APPLICATION FOR
URBAN DESIGN COMMISSION
REVIEW AND APPROVAL

PROJECT ADDRESS: 4841 Annamark Drive

Project Texas Roadhouse Madison, WI
Project # 20050922.2
Re Resubmittal: Urban Design Commission – Final Approval

SHEET NUMBER
C-7.1

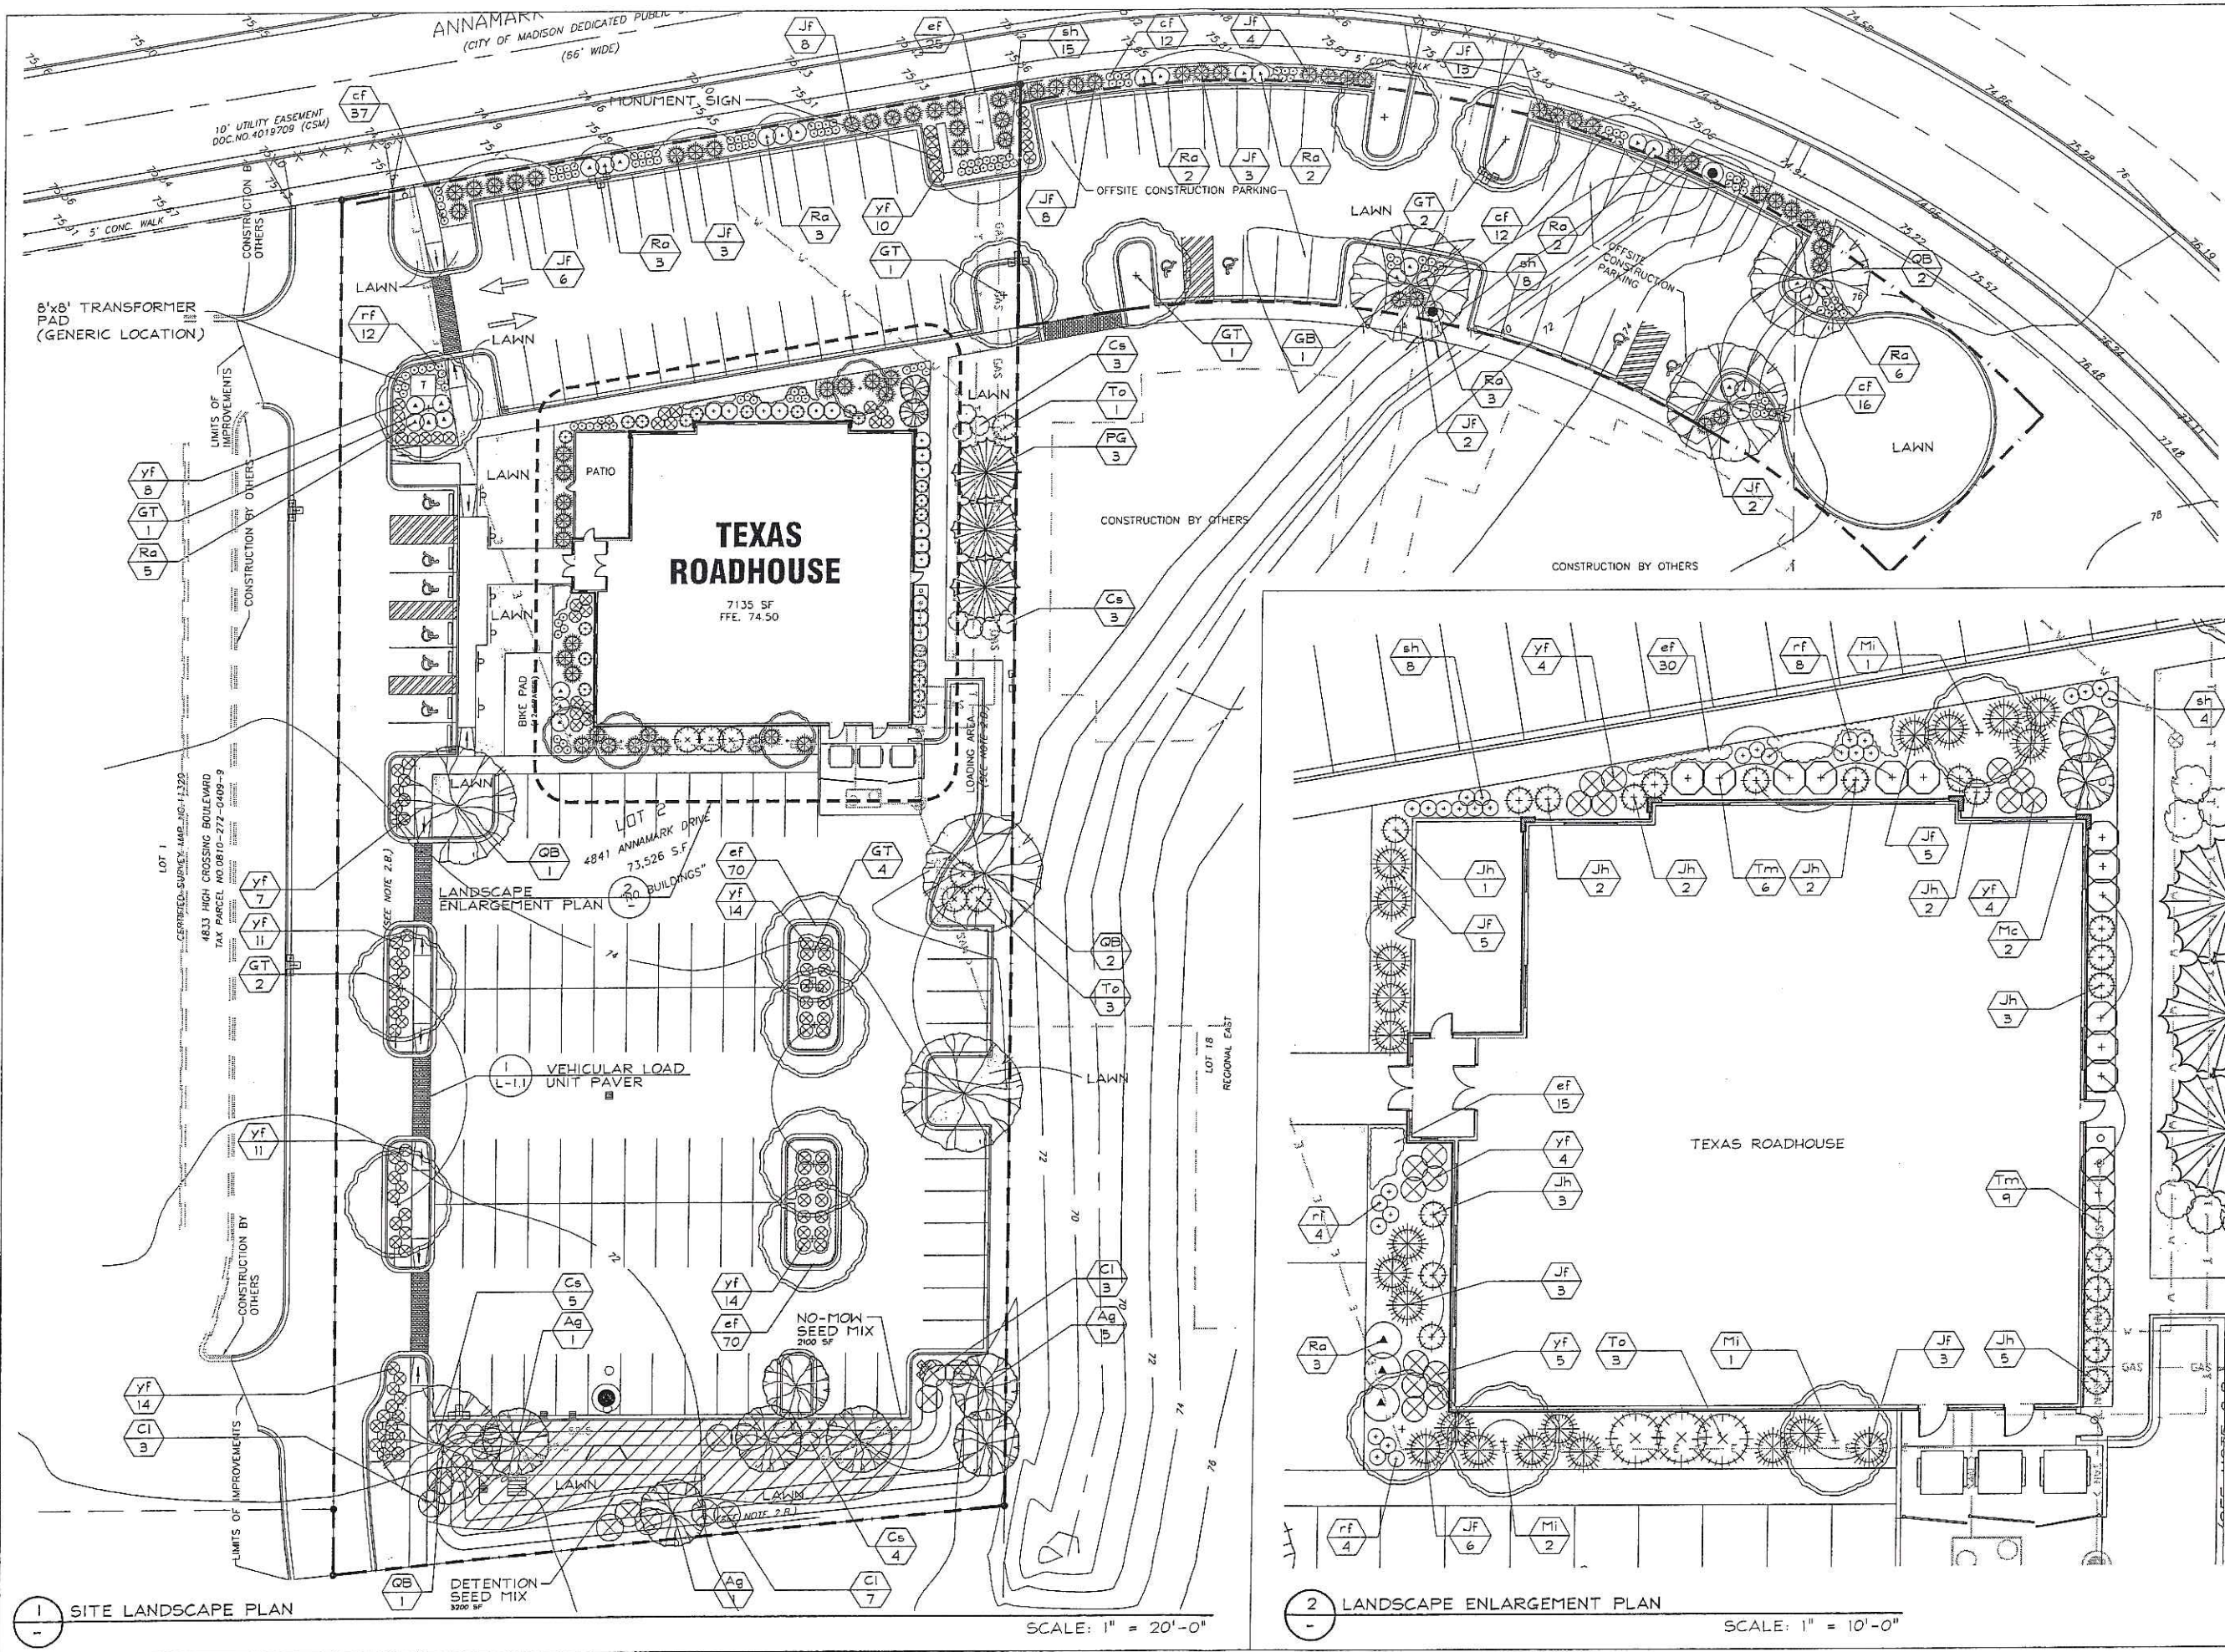
1. The photometric plan (Sheets C7.0 & C7.1 of the Civil Engineering Plan Set) has been revised to further reduce the "hot spots."
2. The architectural elevations have been revised to now show the "Type F12" emergency wall-pack fixtures located at the rear of the building. I have included the manufacturer's cut sheet for this wall-pack that indicates it is rated as a full cutoff fixture and is dark-sky approved.
3. The floor and seating plans have been updated to show the outdoor patio layout.

OPTION
**LANDSCAPE
LAYOUT PLAN**

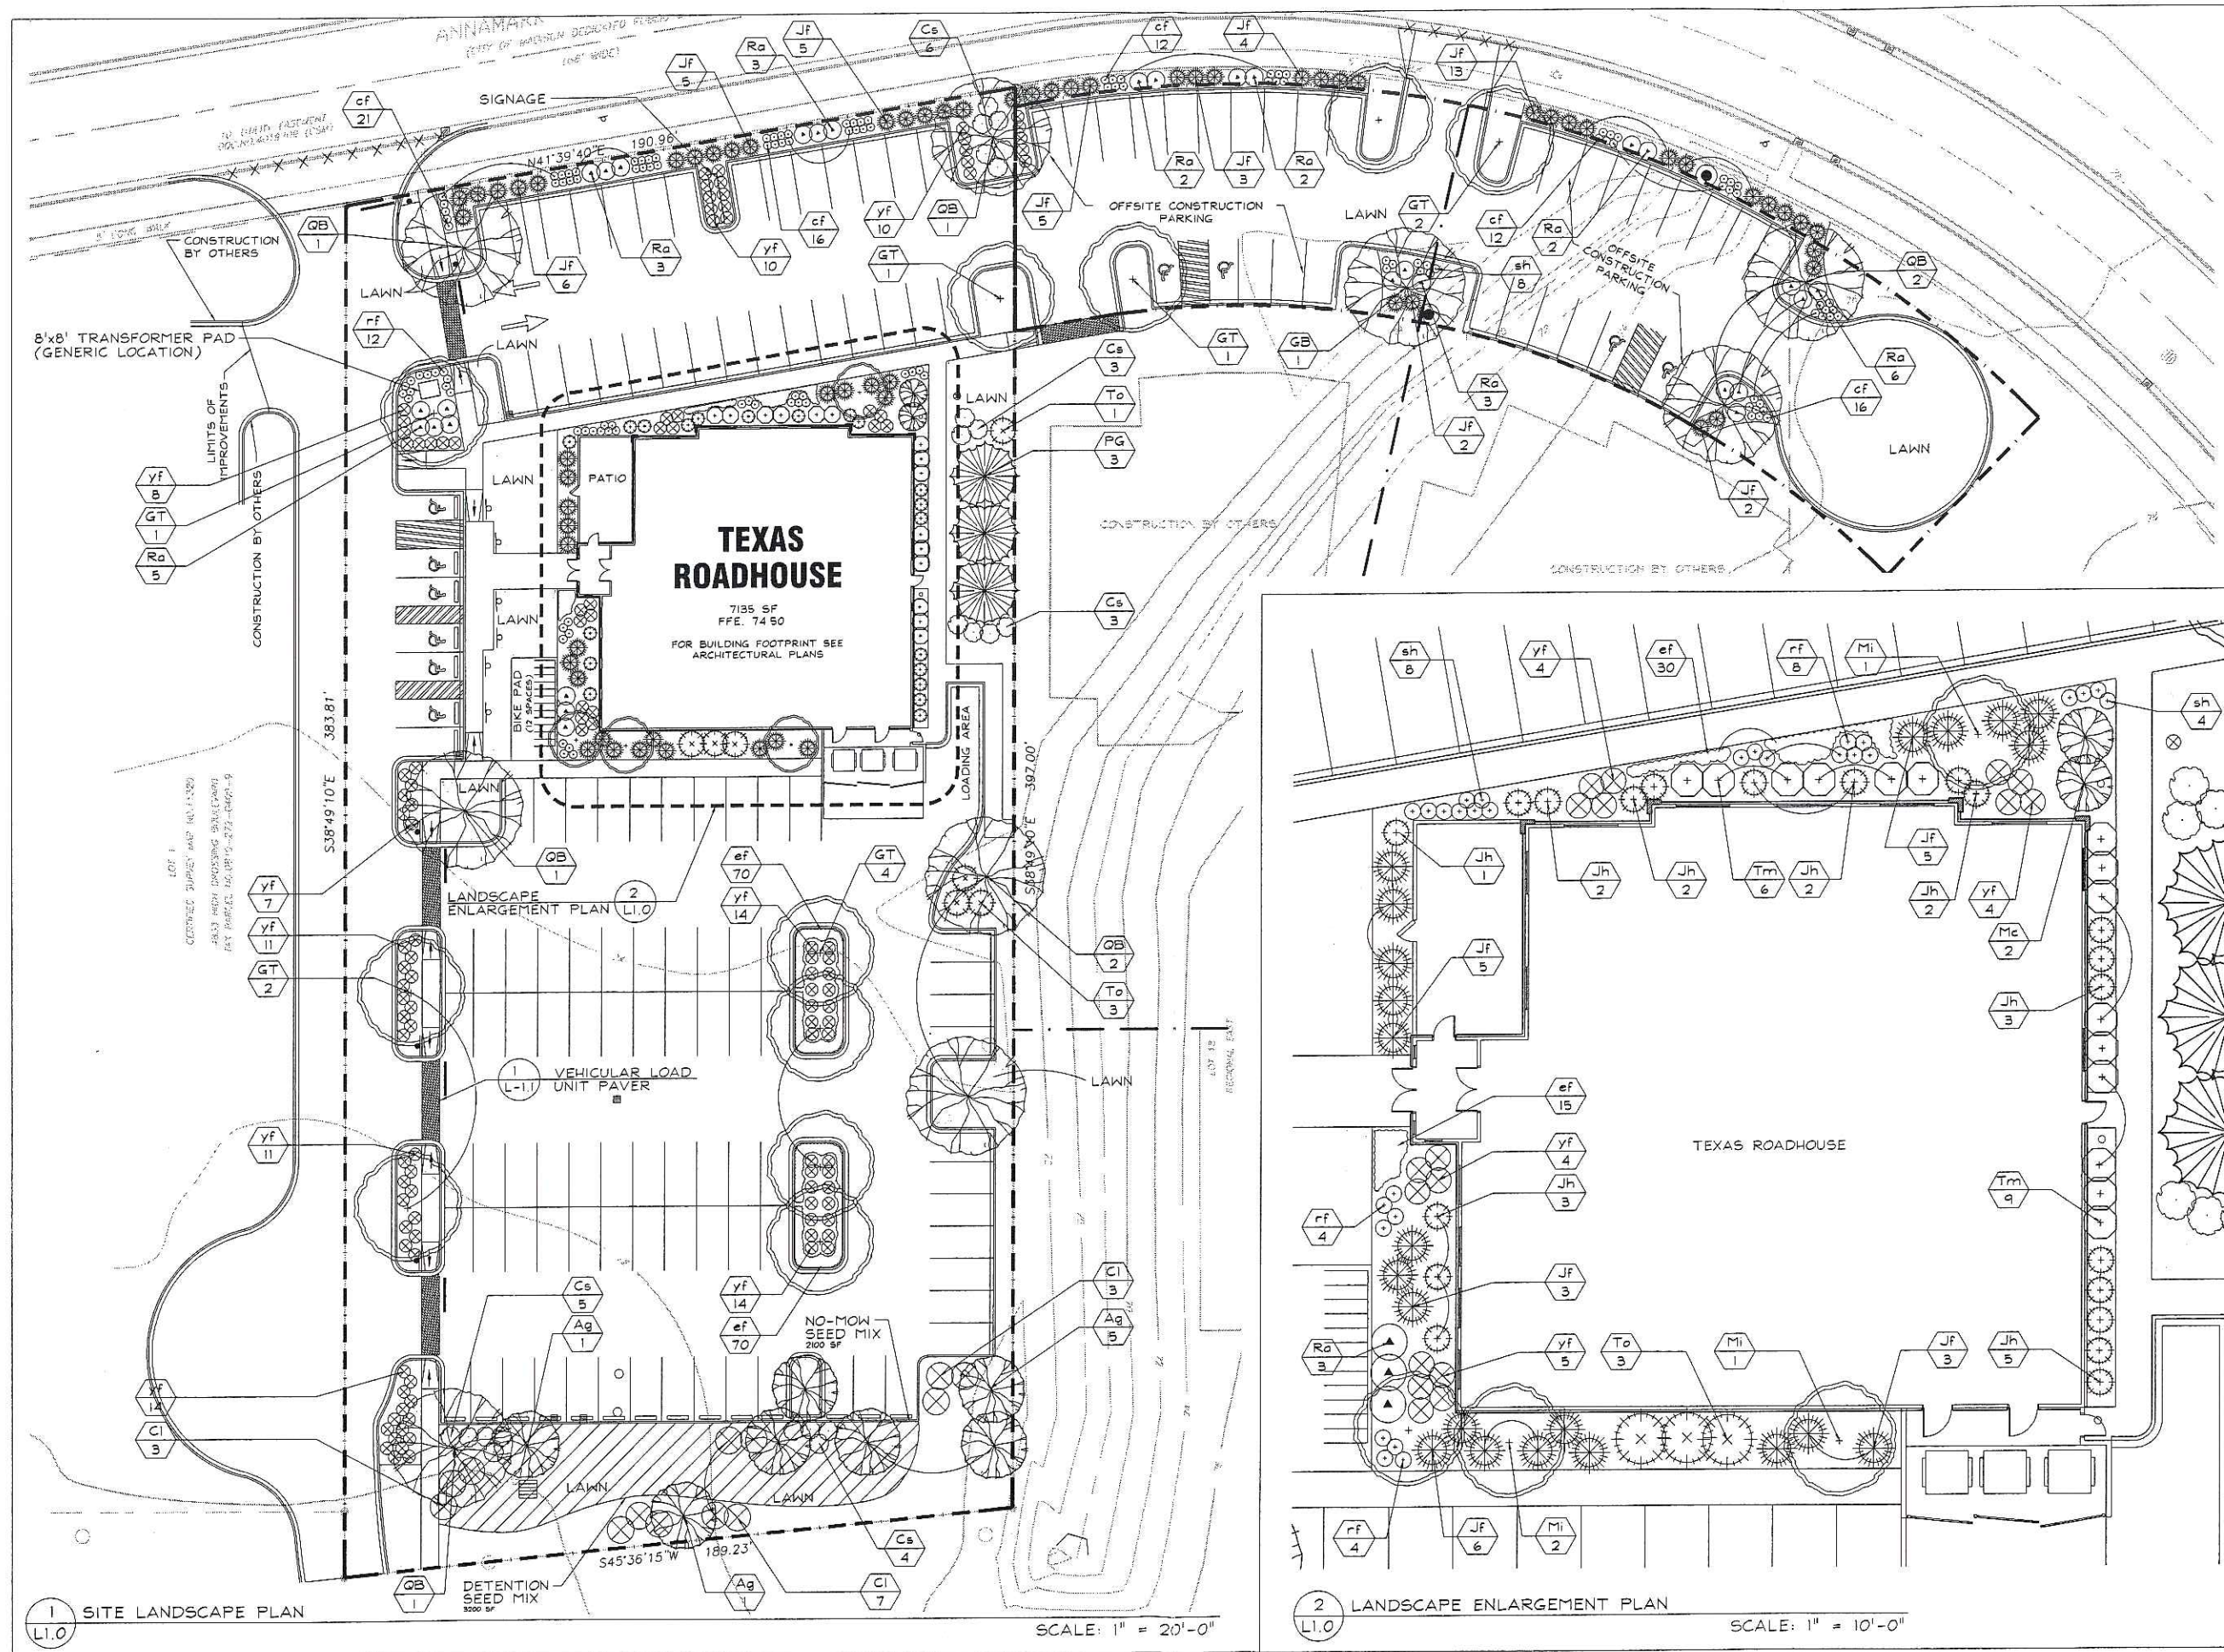
4. The landscape and site plans have been revised to incorporate several large deciduous trees along the northernmost row of parking along Annamark Drive. In order to eliminate a conflict with the pylon sign in this area, the sign was moved several parking spaces to the east. A new island was created around the base of the sign to afford enough room for landscaping. As such, the island that previously held the pylon sign was resized to accommodate the "lost" parking space for the new sign location. The total on-site parking count remains at 115 spaces.
5. The site plan was also revised to reflect a fire lane turnaround per Fire Department review comments.
